An Independent Analysis Of NIST's Scientific Methods And Assumptions

Scott Jones BSc (scottjones05@aol.com)

Summary of Key points

Fig. 1.3

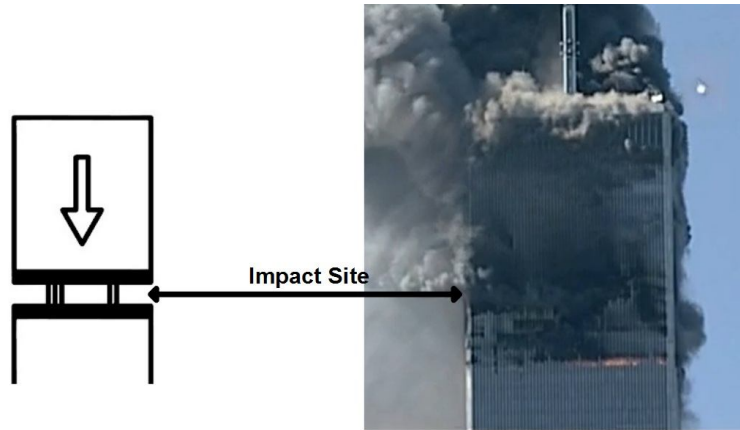
The question of whether the upper section of the tower was rigid at the instant of impact can also be seen when comparing the diagrams in Fig. 1.3, 1.4 and 1.5 from The Paper⁹ showing the stages of ‘progressive collapse’ with the visual record:
